REQUEST FOR INFORMATION	DATE: July 11, 2016	NO.: RFI-198
--------------------------------	----------------------------	---------------------

Project Name:	15051-Webster University Interdisciplinary Science Building	Project No.:	15051
---------------	---	--------------	-------

Subject: Level 1 duct coordination with additional screenshots

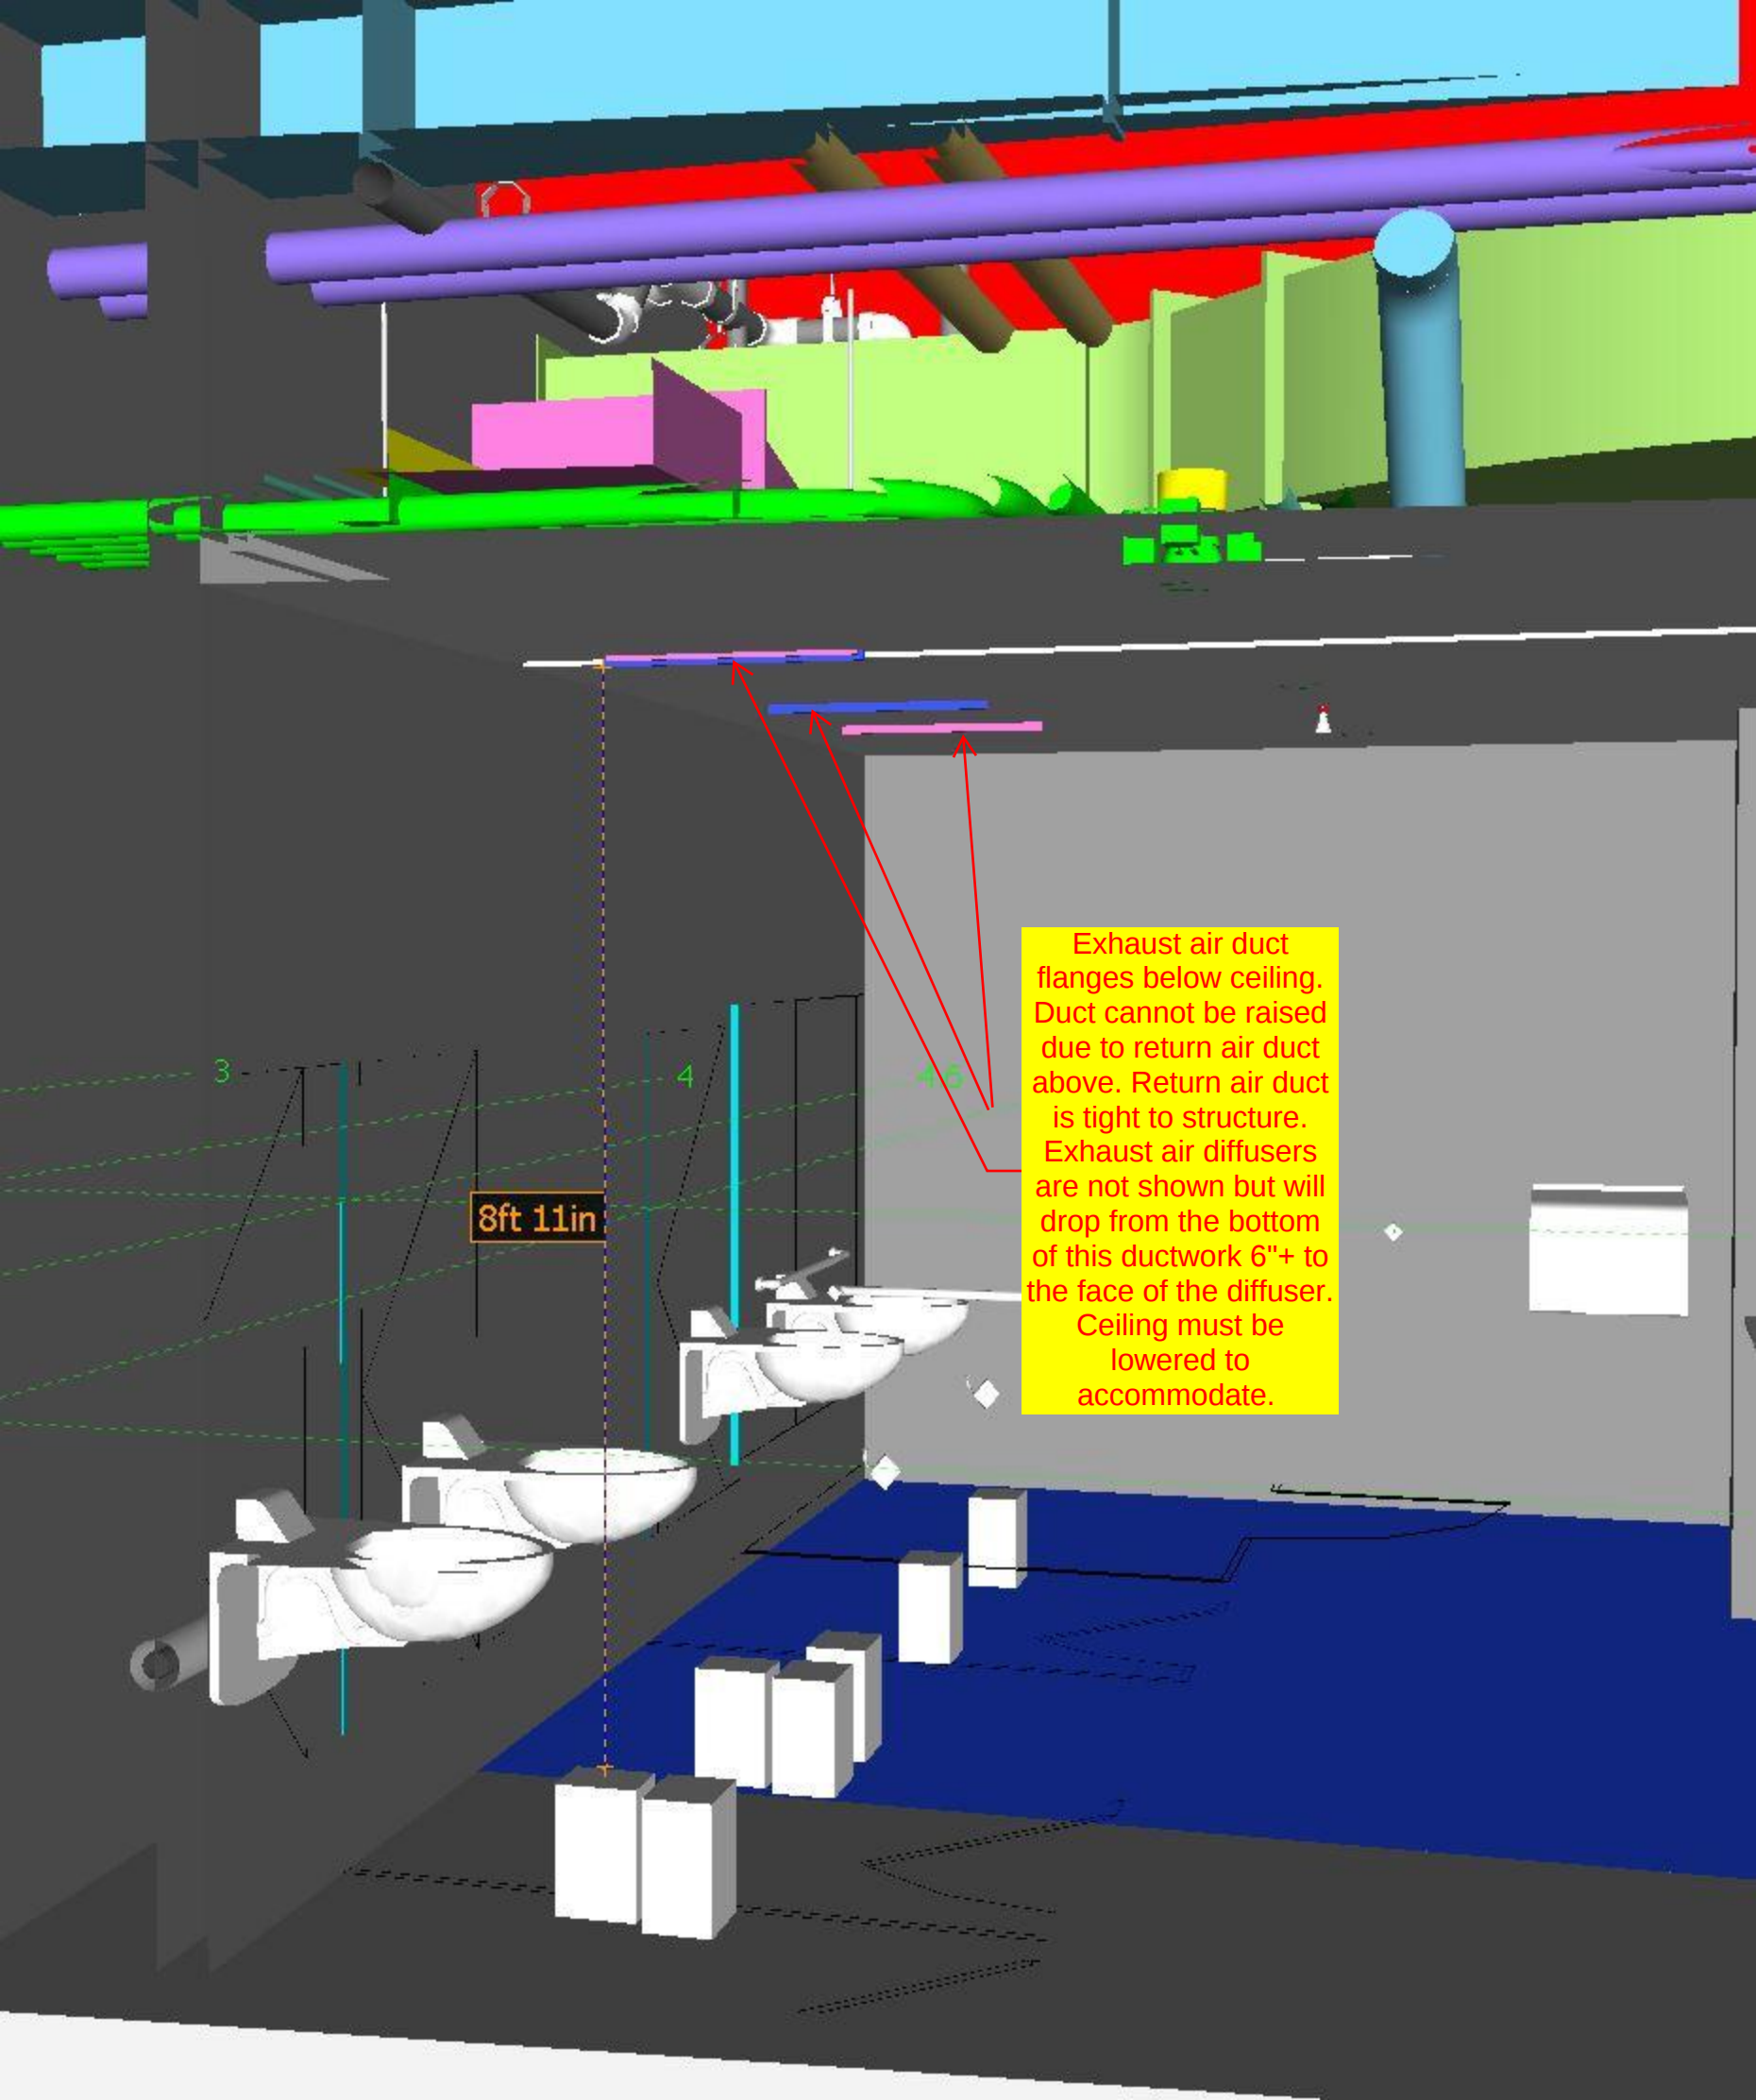
Elevation Issues: (Exhaust flange elevation PDF)

- The pink exhaust duct is as high as it can go and the flanges are below ceiling elevation. The Green return duct is also tight to plumbing drains and steel that cannot be adjust up. There are taps that come off the bottom of the exhaust duct to serve the bathrooms and will add 6" or so to the bottom elevation which will put us even lower.

Exhaust air duct flanges below ceiling. Duct cannot be raised due to return air duct above. Return air duct is tight to structure. Exhaust air diffusers are not shown but will drop from the bottom of this ductwork 6"+ to the face of the diffuser. Ceiling must be lowered to accommodate.

Per discussion last week - Ceiling in Level 01 toilet rooms 177 AND 179 will be lowered to 8'-4". Other toilet room ceilings will not be lowered. Further exploration will be done at upper level ceilings.
Width of entry will remain as is to accommodate sightlines and clearances.
Actuator access to be via access panel inside toilet room.
Wood ceiling panel will be accessible via concealed mounting.
Within the toilet rooms, access panels will be sized and located to be aligned with each other.

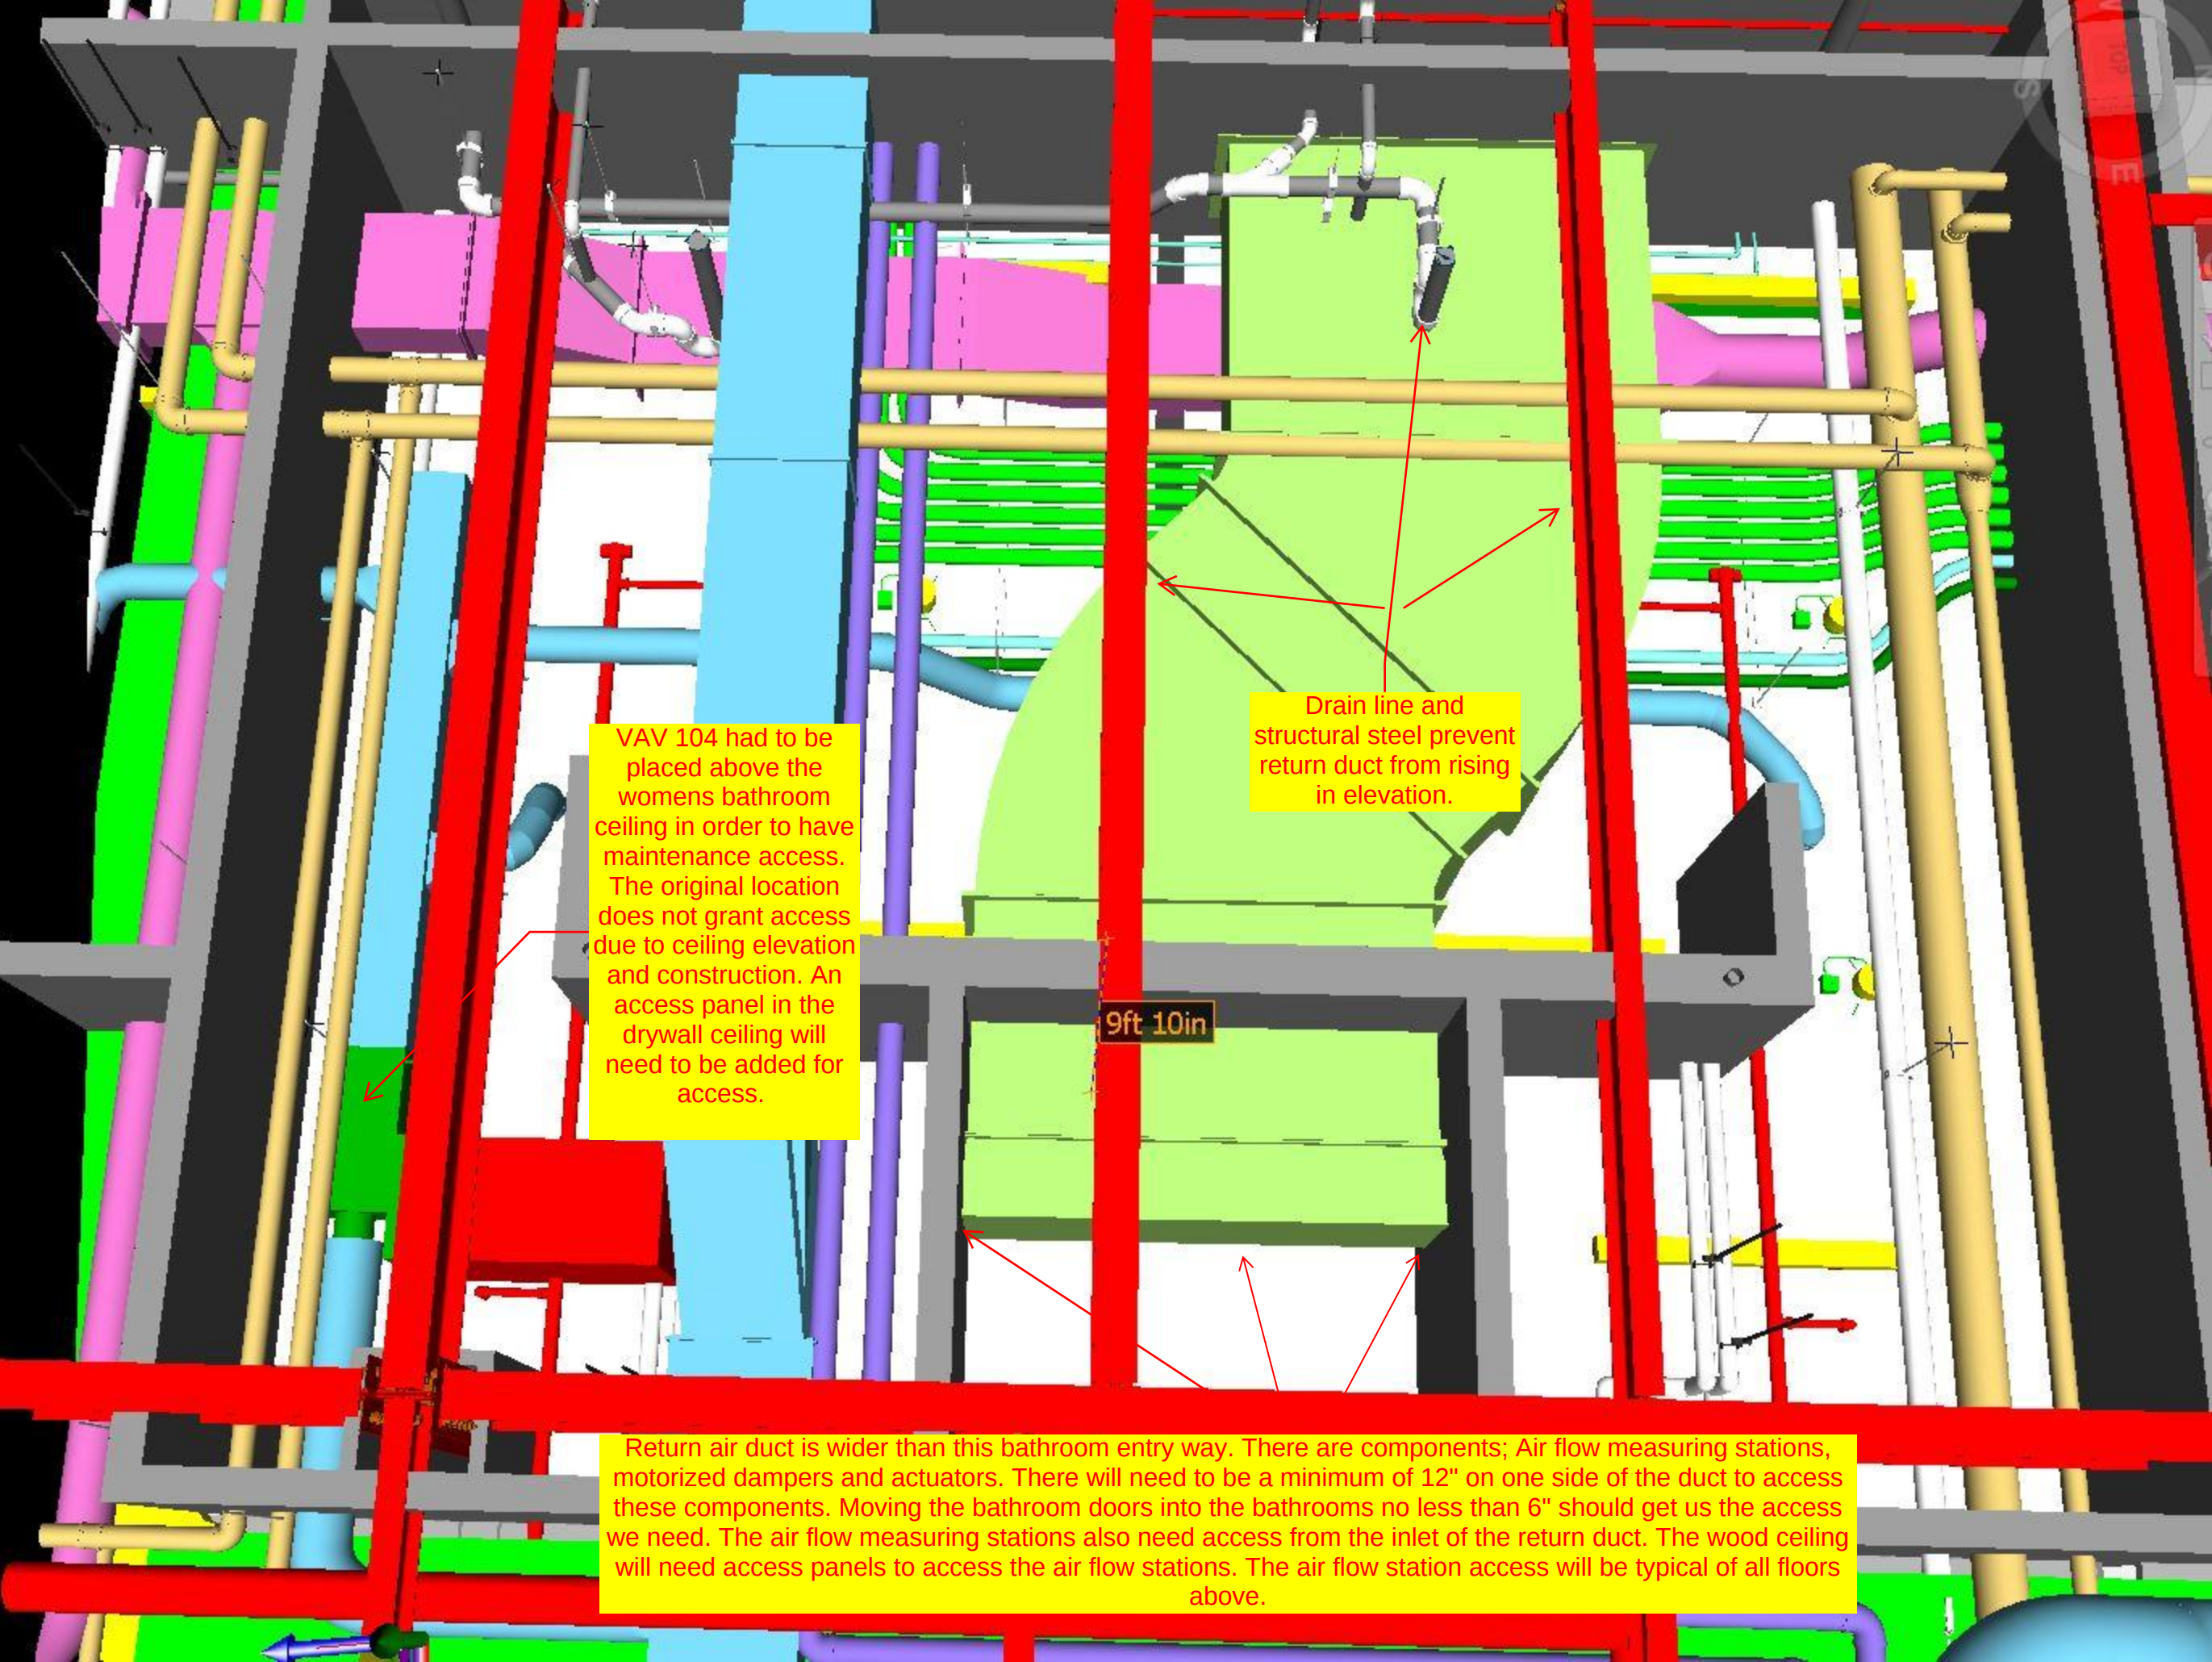
Interference and Access Issues: (bathroom looking west PDF)

- VAV 104 had to be moved into the women's restroom due to the lack of ceiling space and elevation in the corridors. An access panel will need to be installed below this box for maintenance access. The duct taps that feed the men's restroom also cannot fit with the current elevations and will be interfering with the current ceiling.

- At the inlet of the green return duct, the duct itself is wider than the entry way to the bathrooms. We will have components at the inlet of this duct that will need to be accessed. A motorized damper that will need at least 12" on one side of the duct to access the actuator. If the doors to the bathroom move in towards the bathroom a minimum of 6" each, it should give us enough room for access. The return airflow measuring station will also need that access along with access to the inlet of the duct. The airflow station has components that can only be accessed from the inlet. Access panels will need to be cut into the wood ceiling or the ceiling changed to accommodate access.

VAV 104 had to be placed above the womens bathroom ceiling in order to have maintenance access. The original location does not grant access due to ceiling elevation and construction. An access panel in the drywall ceiling will need to be added for access.

Drain line and structural steel prevent return duct from rising in elevation.

Return air duct is wider than this bathroom entry way. There are components; Air flow measuring stations, motorized dampers and actuators. There will need to be a minimum of 12" on one side of the duct to access these components. Moving the bathroom doors into the bathrooms no less than 6" should get us the access we need. The air flow measuring stations also need access from the inlet of the return duct. The wood ceiling will need access panels to access the air flow stations. The air flow station access will be typical of all floors above.
